# PAM8406 (and PAM8403)

Now, since this chip is such a simple layout, I thought maybe I can do better, which brings me to the real reason for this thread. I have done an initial layout for a PAM stamp, and would like some feedback. I based my layout on the Chinese board, but made several improvements.

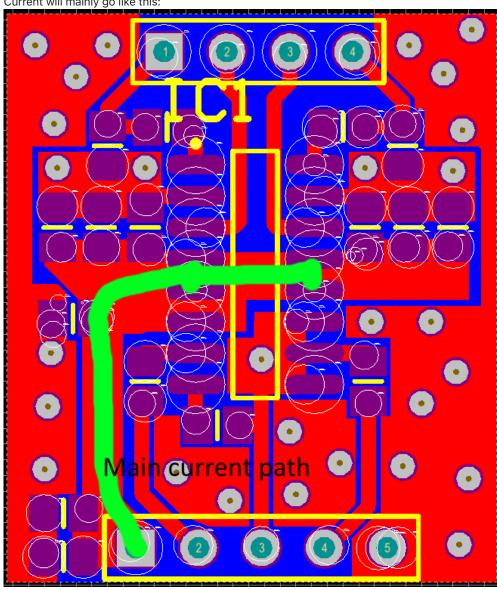
To me, the actual bypass is kinda "suboptimal", as bypass caps are not in the loop.

Current will mainly go like this:

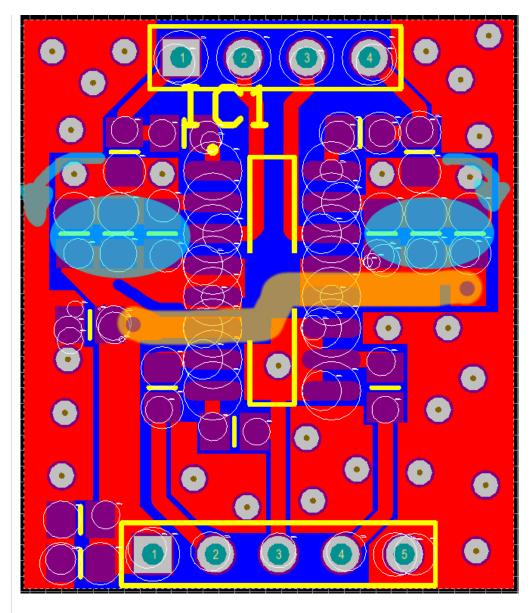
I'd recommend:

Current should go trough the pads of the caps. "Positive" will face to the chip as close as possible. For this, the caps need to be rotated by 90°. Decoupling per channel/side, so no mid connection of the rail but trace at the bottom to link via Vias. Tracks lead into decoupling "tank" from there to the chip. If needed, reduce to 2 caps per side at the chip, like i.e. 10uF + 100nF. Keep DC-bias in mind, resulting capacitance will be lower

PAIM8/406L1.pag

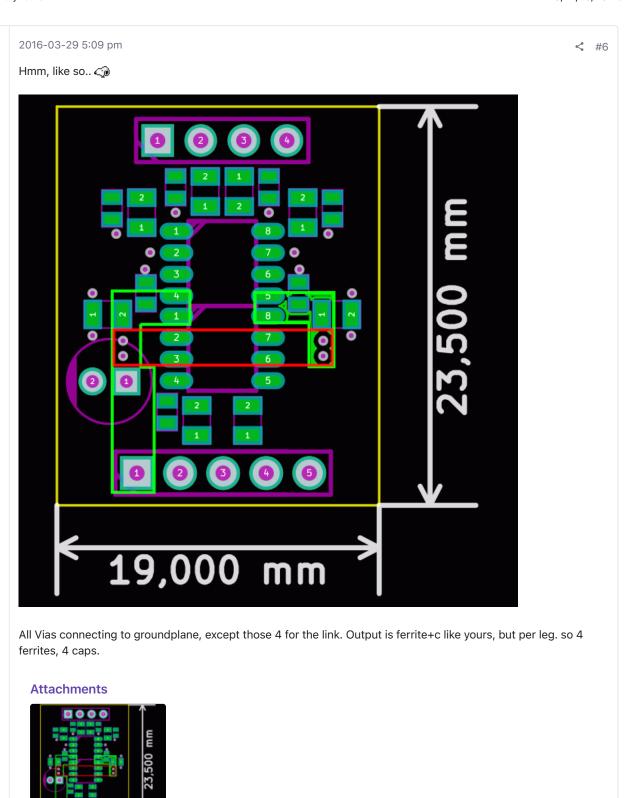
I have not drawn in ground planes yet, but all via will be ground aside from the 3 connecting to the blue bottom power trace.

I also added jumpers for SHDN, MUTE, and MODE.

One ground-via per cap, even if you do groundfill later. Any reason to have only "half-filter"? EMI is on both outputs, so better go for "full filter". (Ferrite+C)

Pin3/14 directly to ground at thermal pad will free up the "problem" with the caps and routing the outputs.

Because I had misinterpreted the diagram in the 8403 datasheet . You are 100% correct that I need filter on both lines.

I assume you mean pins 2 and 15? I wasn't sure if it was proper to go directly to thermal pad ground but since it seems to not be a problem I will do it that way as it does simplify things. Should I tie pin 11 on to TP ground also rather than do an external via?

Yes, and route AGND\_in on top to thermal-pad only. (coming from your source) PGND, coming from the supply, is directly connected to the ground plane.
